Sundry Notices and Reports on Well	\$ 1% 7: L5		
	MINGTON, NM	5.	Lease Number NM-09840 If Indian, All. or Tribe Name
		7.	Unit Agreement Name
Name of Operator MERIDIAN OIL

PLUG & ABANDONMENT PROCEDURE

Tibbar Federal #4 Basin Dakota NE, Sec. 25, T26N, R6W San Juan County, New Mexico

CONDITIONS OF APPROVAL

Tibbar Federal #4 PROPOSED P&A

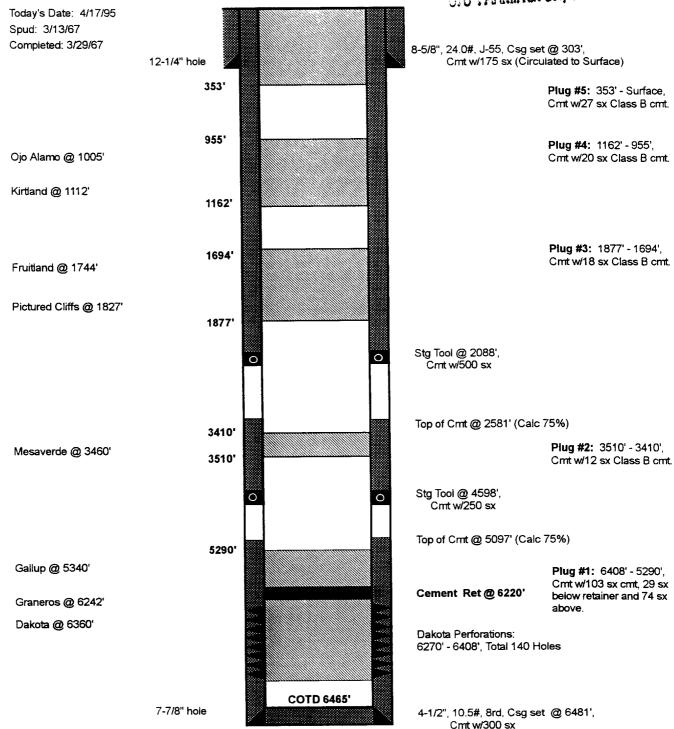
- 1. Plugging operations authorized are subject to the attached "General Requirements for Permanent Abandonment of Wells on Federal and Indian Leases."
- 2. **Mike Flaniken** with the Farmington Office is to be notified at least 24 hours before the plugging operations commence (505) 599-8907.
- 3. The following modifications to your plugging program are to be made (when applicable):
 - 1.) Extend the Fruitland-Pictured Cliffs plug from 1877'-1694' to 1935'-1602'. (Pictured Cliffs top @ 1885' and Fruitland top @ 1652')
 - 2.) Move the Ojo Alamo cement plug from 1162'-955' to 1258'-1059'. (Kirtland top @ 1208' and Ojo Alamo top @ 1109')
